# Planning Services Sign Permit Review Form

Date of Submittal	Application Number	Applicant	Landowner
8/26/2021	SIGN2108-0001	Grey Outdoor LLC	STKI Leasing LLC

Contact Person	Contact Number	PIN Number	Sign Location
Guy Williamson	252-521-5555	1515-54-4695.000	1280 Bud Hawkins Rd.

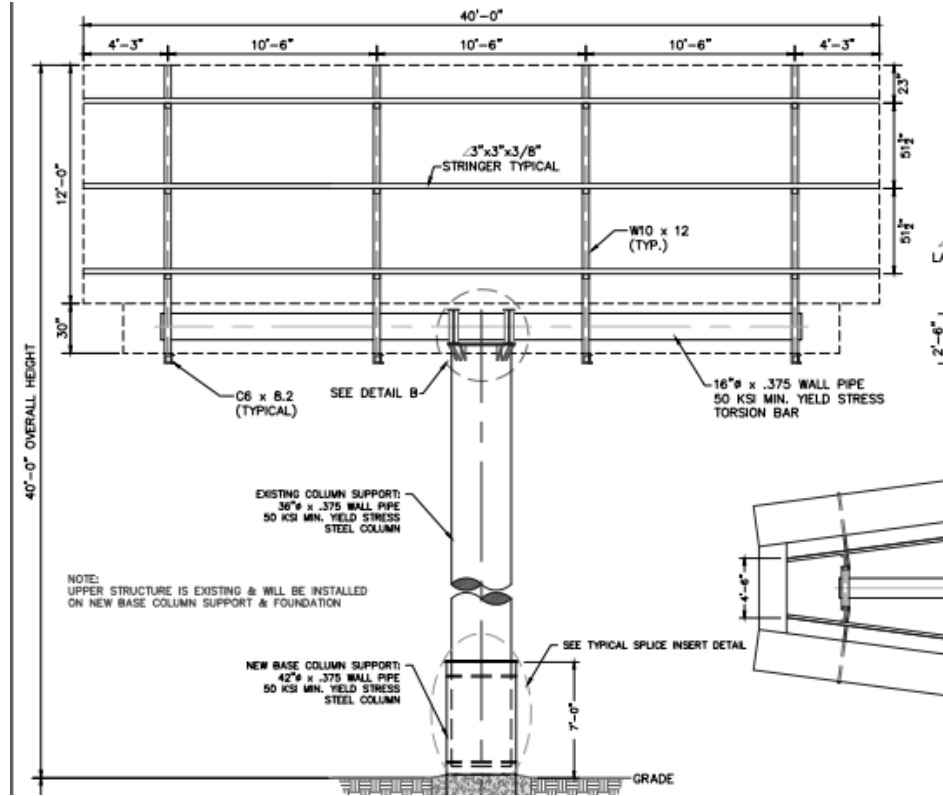
Comments	<p>General Sign Information: The sign is classified as a Business Sign: Interstate Highway. The sign is not licensed with NCDOT as a billboard. The sign <b>cannot be used</b> for the purposes of off-site advertising – now or in the future. The application submitted is for the sign to be relocated as apart of the I 95 widening project.</p> <p>Comments</p> <ol style="list-style-type: none"> <li>1. Please be advised that only 1 business sign is permitted on the property. No other ground sign advertising for the property will be permitted. If more than one sign is found to be located on the property, the sign will not be permitted to be relocated as proposed.</li> <li>2. The pool attached to the sign in the rendering will not be permitted when the sign is relocated. The structural plans indicate it is not attached. The pool will not be permitted to be attached to the sign.</li> </ol>
